CARRIER, INSTALLATION, FULL TRACKED, MKs 2 AND 2/1 (FV439)

MODIFICATION INSTRUCTIONS AND INDEX

MODIFICATION INSTRUCTION NO. 1

SUBJECT: EMER TV E107/9 Modification Instructions No. 1 to No. 8

Fig 1 - Rear floor plate (FV 585921) modification detail
(FV 439 Mk 2/1 vehicles only).

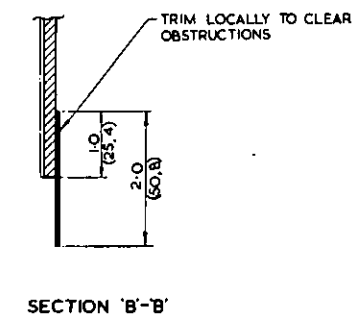
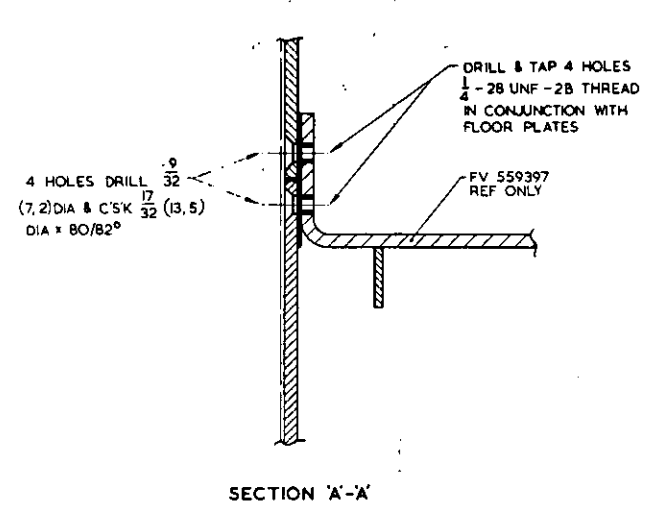
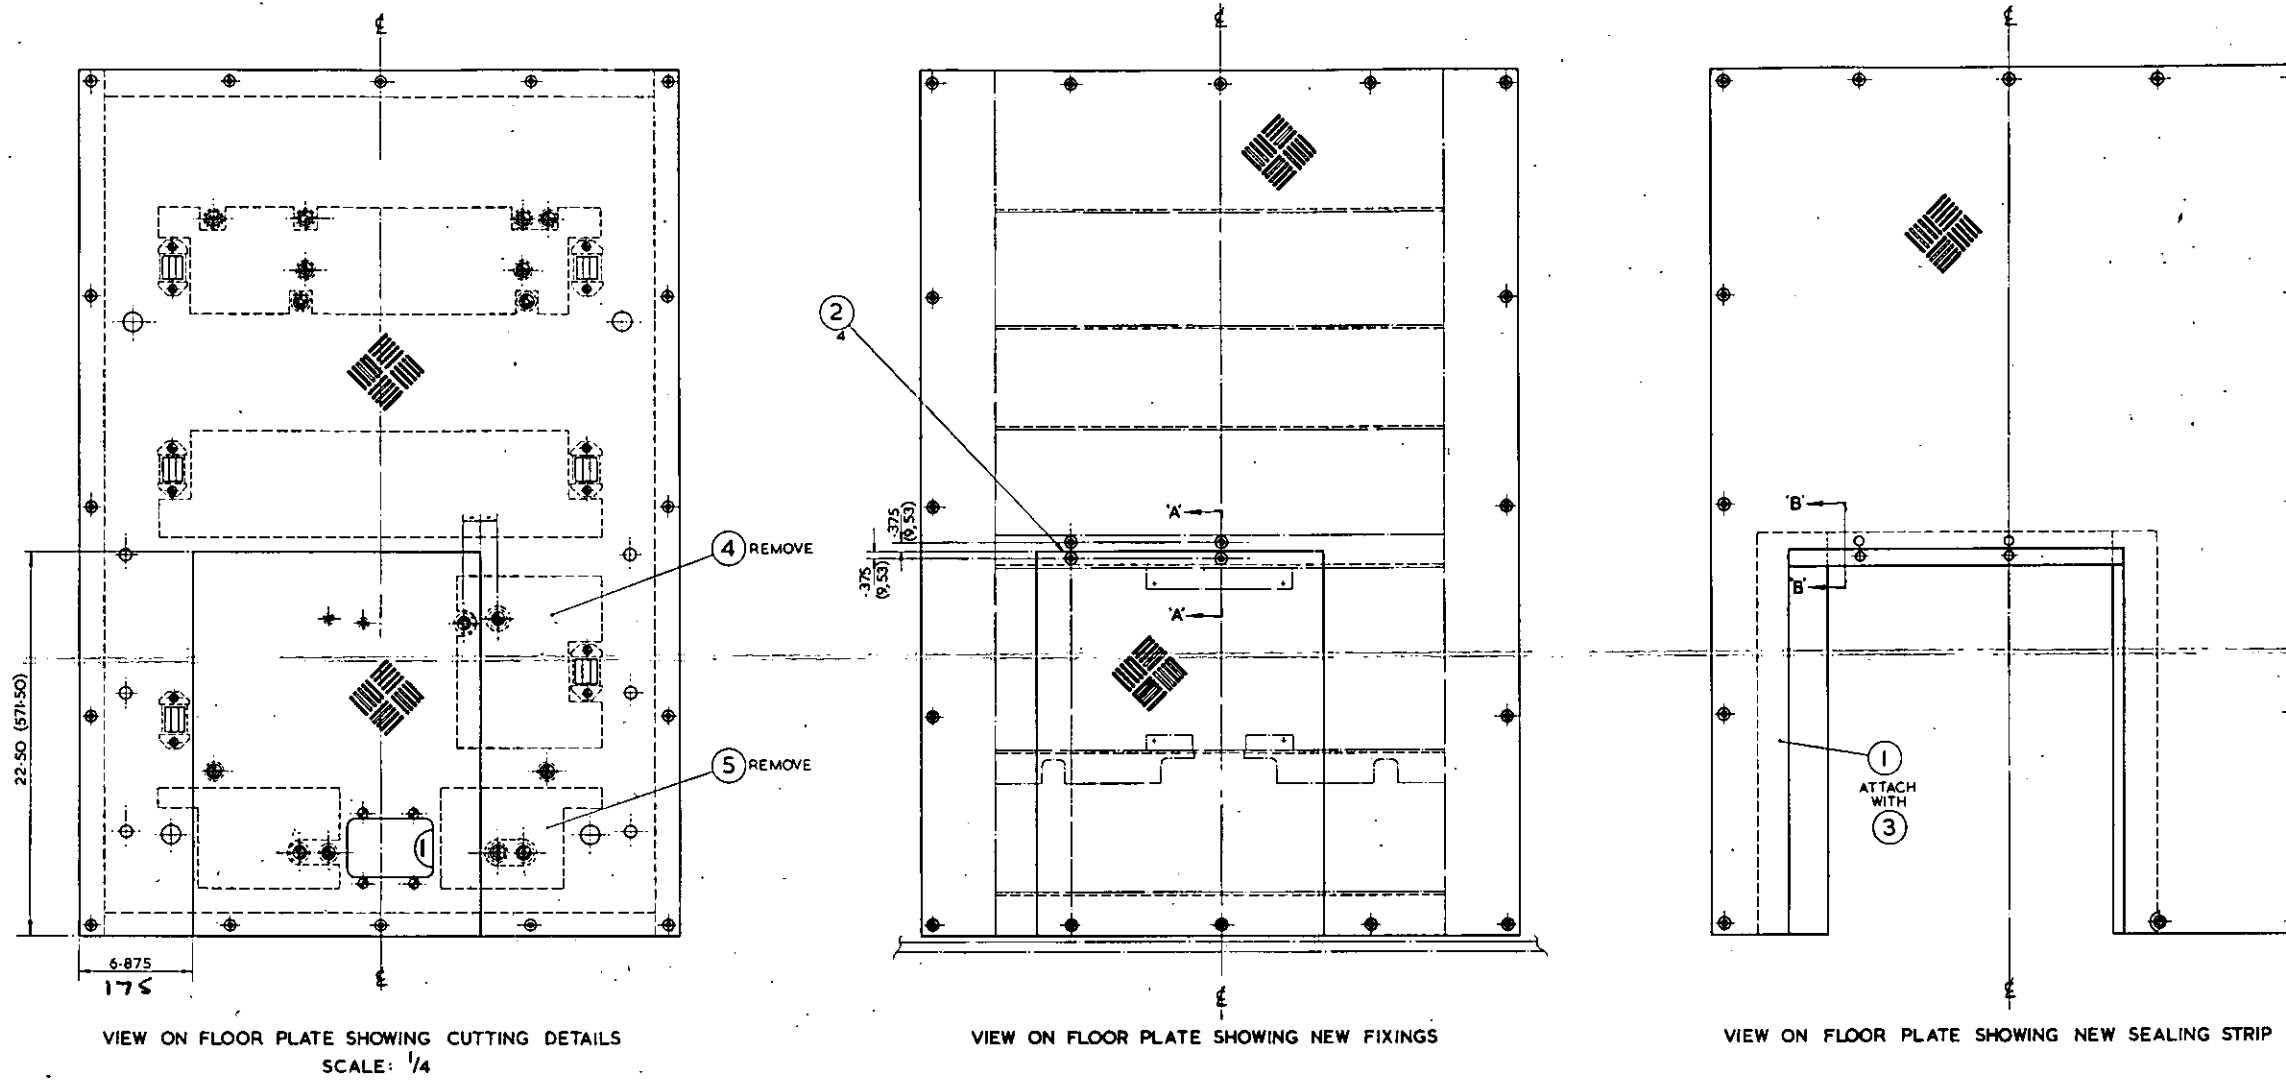
1. To improve access to the fuel pump and filter units, the rear floor plate is to be modified.

- a. Remove rear floor plate from vehicle.
- b. See Fig 1.
 - (1) Remove and discard both rubber sponge pads (items 4 and 5).
 - (2) Cut floor plate as indicated in l.h. view ensuring that the r.h. 'cut' line passes equidistant between the two bosses as shown.

- (3) Drill the two cut pieces of floor plate as shown in centre view and section 'A-A'.
 - (4) Fit the two pieces of floor plate and secure using some of the existing fixings. Spot through the four new holes in the floor plates on to the under-floor structure. Drill and tap four, $\frac{1}{4}$ in. UNF holes in under-floor structure.

- (5) Cut rubber sheet (item 1) into appropriate lengths of 2 in. strips and affix to aperture of main floor plate as shown in r.h. view and section 'B-B'.

- (6) Fit both parts of floor plate to vehicle and secure using retained fixings and the additional qty four $\frac{1}{4}$ in. UNF screws (item 2).

Fig 1 Fire extinguisher mounting front

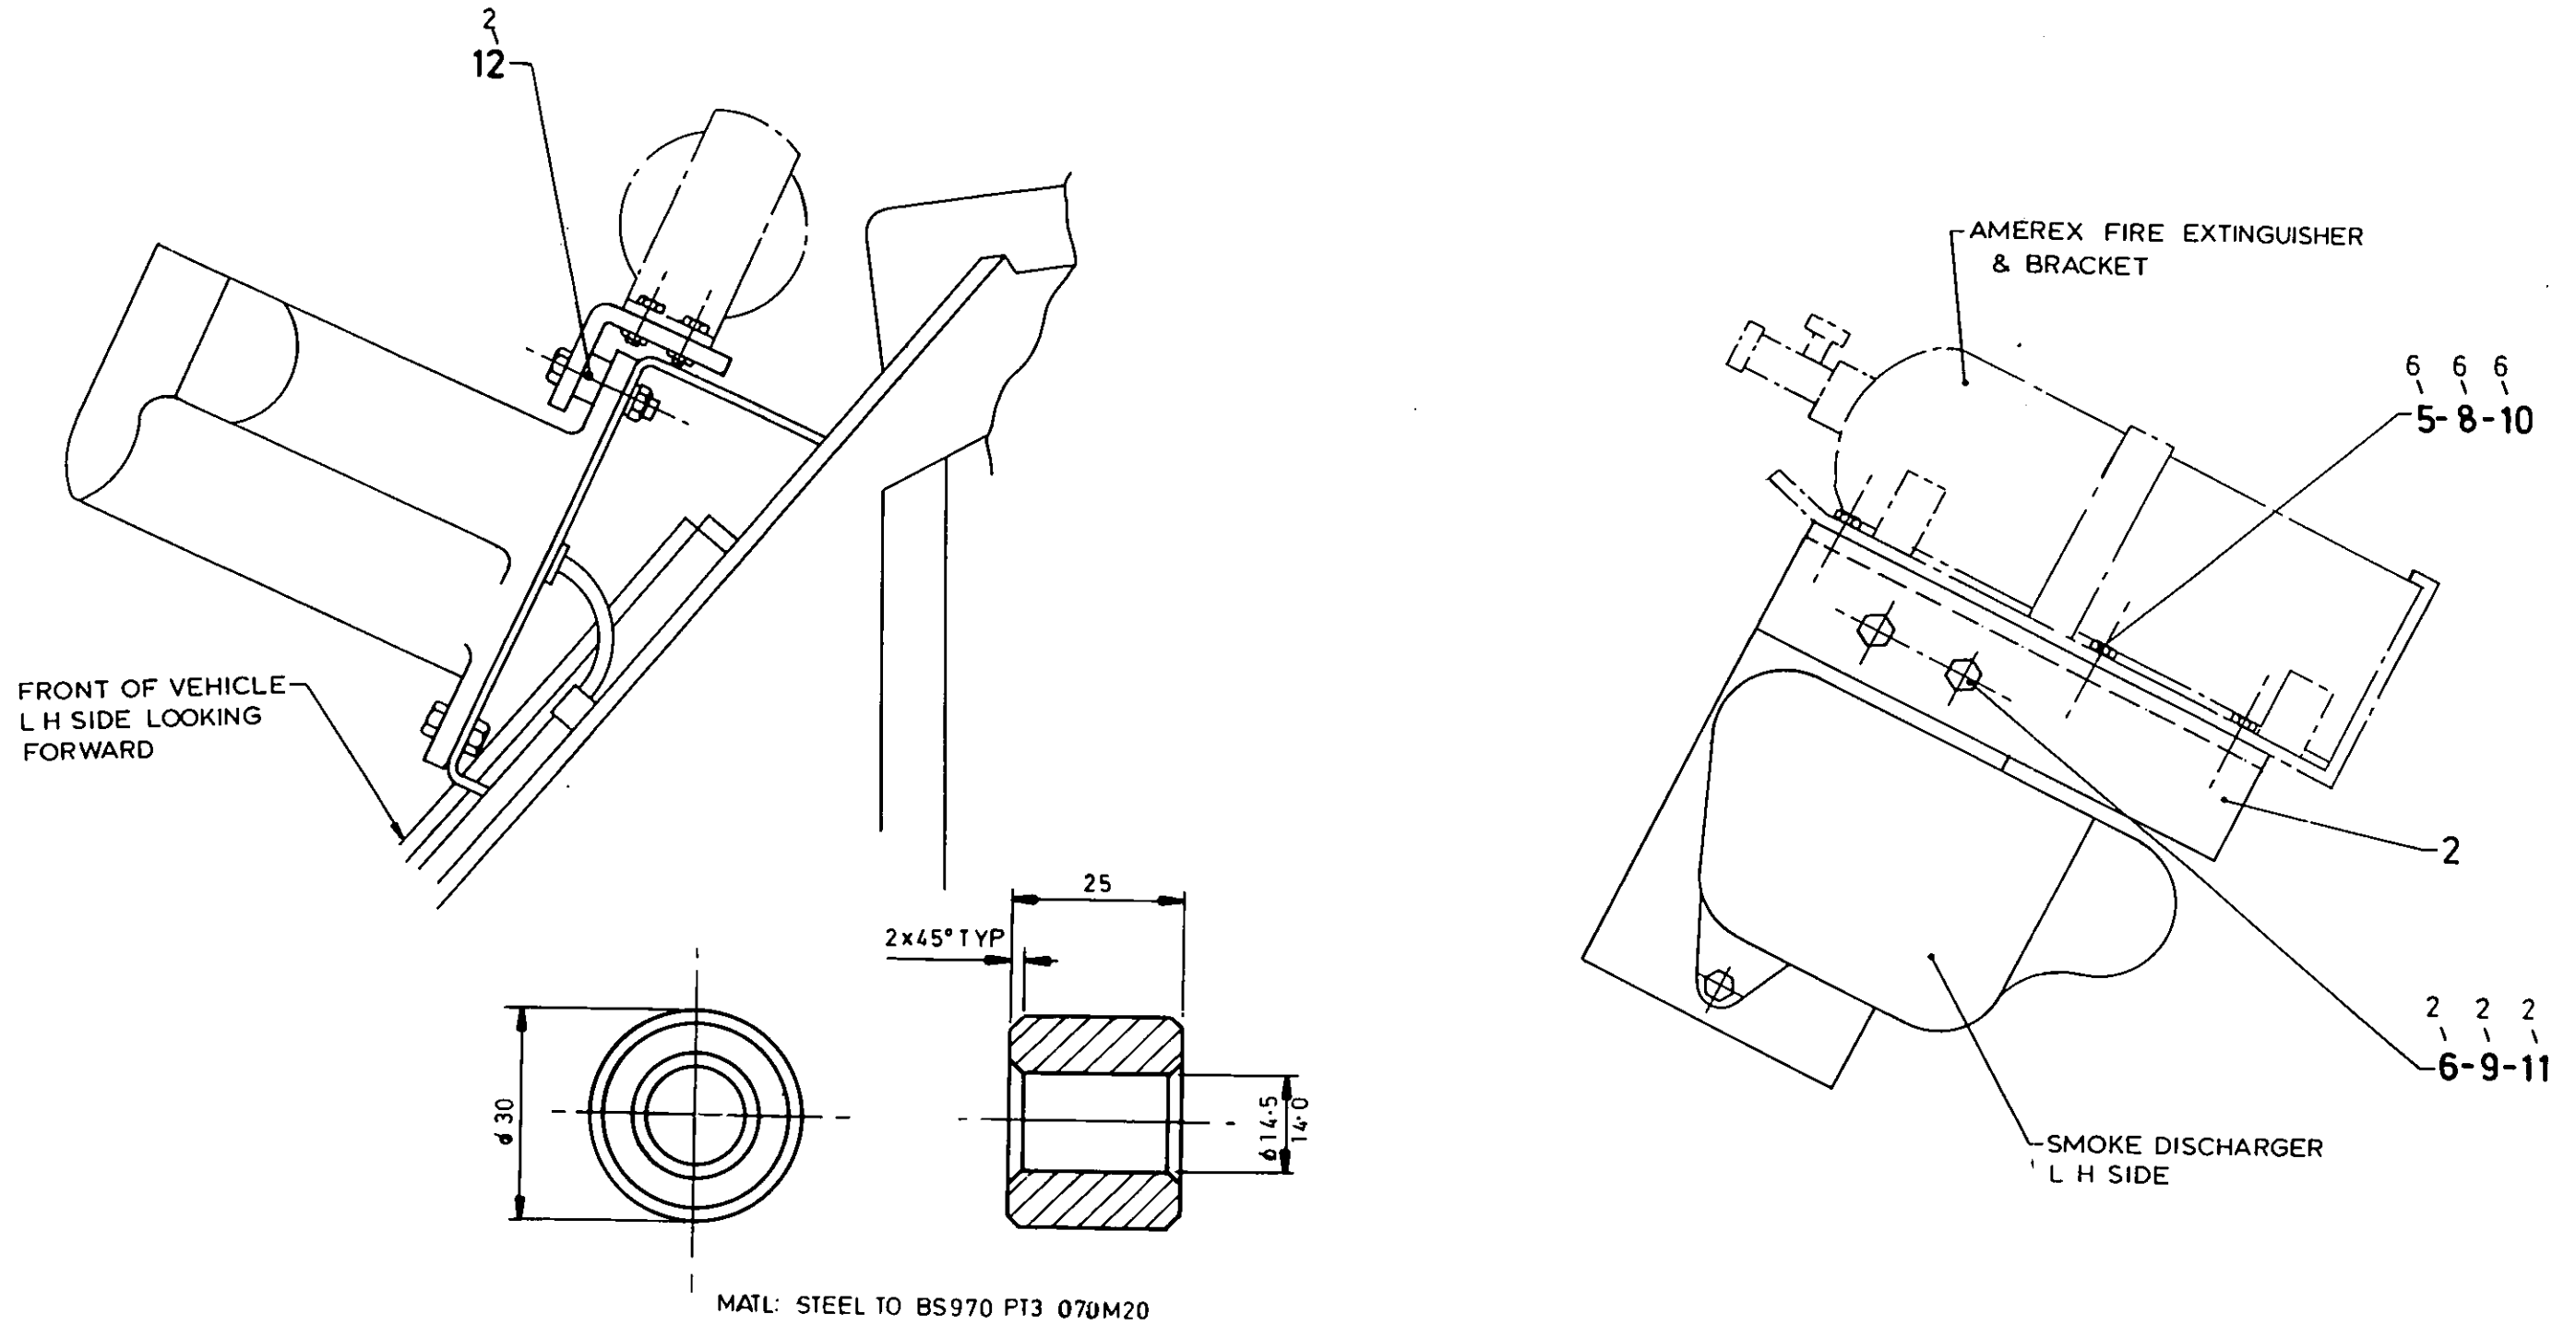
9.3 Remove bolts, nuts and washers (items 13, 14 and 15) from smoke discharger (Fig 1), and attach mounting plate and spacers (item 2 and 12) to smoke discharger brackets using bolts, washers and nuts (items 6, 9 and 11).

Fig.1 Engine cover (FV 847342)

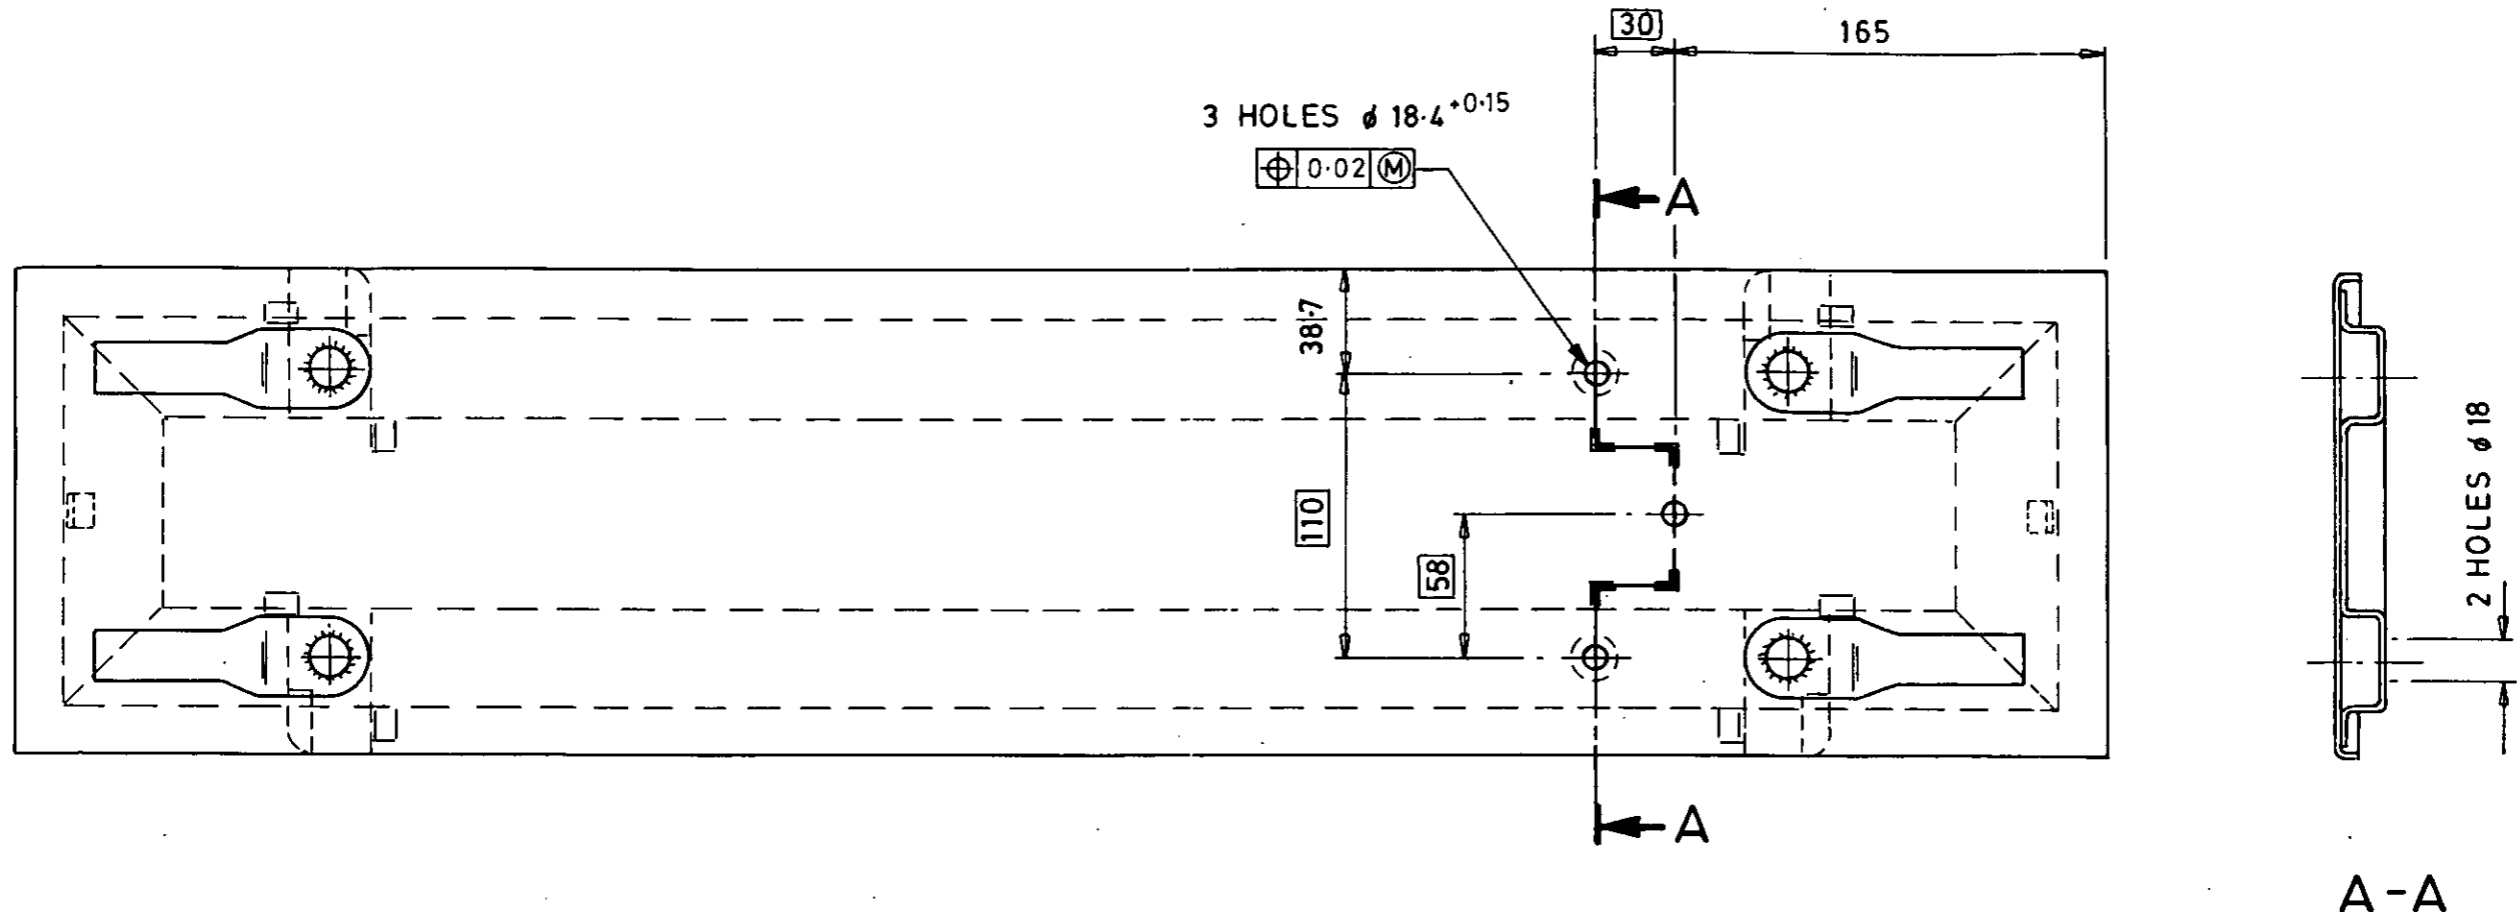
9.1 Remove engine cover (FV 847342) mark out and drill holes in cover refer to Fig 1.

Fig 1 Engine cover (item 13)

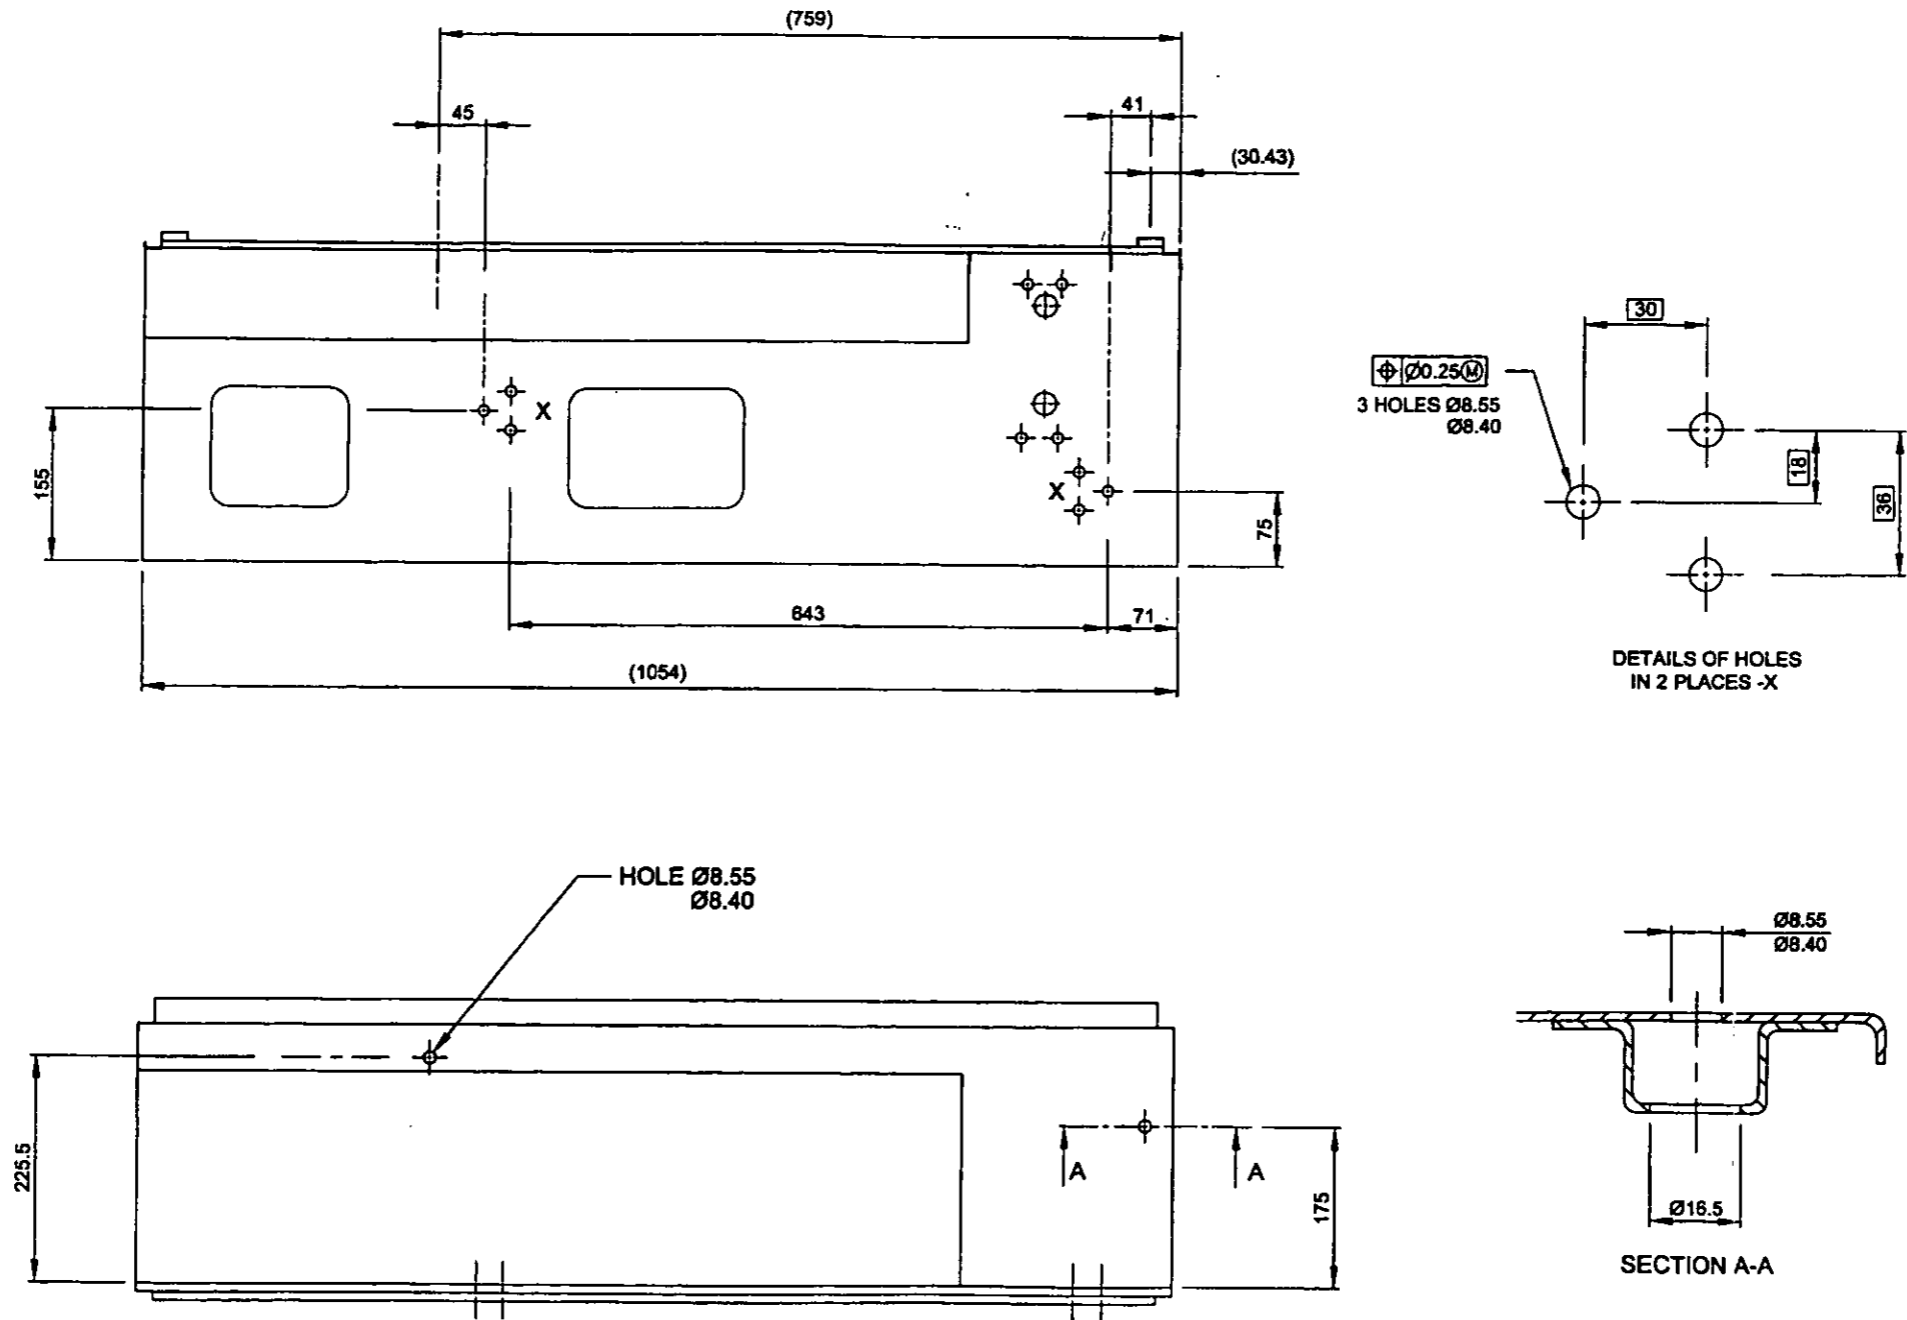
9.1 Remove engine cover (item 13), mark out and drill holes. Refer to Fig 1.
